PKW Scheibenbremsbeläge: MDB2821

Passenger Car Pads: MDB2821

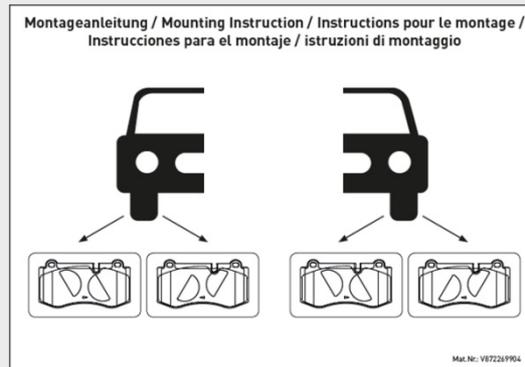
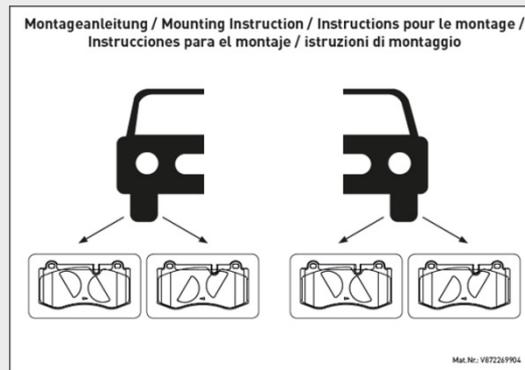
Die Spezifikation der Bremsbeläge MDB2821 wird angepasst. Es erfolgt eine Änderung des Dämpfungsblechs von Vollblech auf Bleche mit Aussparungen (siehe Bilder). Für die neue Blechausführung ist unbedingt die korrekte Einbauseite zu beachten, auf die auch mit Hilfe kleiner Pfeilaussparungen hingewiesen wird. Zusätzlich wird jeder Box eine zusätzliche Montageanleitung beigefügt:

We will change the specification of MDB2821. The full cover shim will be changed to a version with cut outs (see pictures). For the new shims it is absolutely necessary to pay attention to the correct mounting side, which are indicated by small arrows in the shim. For further explanations see below mounting instruction that is also put inside the box:

Mit dieser Änderung passen wir uns der aktuellen OES-Ausführung an, die vor kurzem ebenfalls aufgrund geräuschempfindlicher Anwendungen (z.B. MB S-Class W221) geändert wurde.

With this change we are in line with the current OES designs where this change was also done in the near past due to some noise critical applications (especially MB S-Class W221).
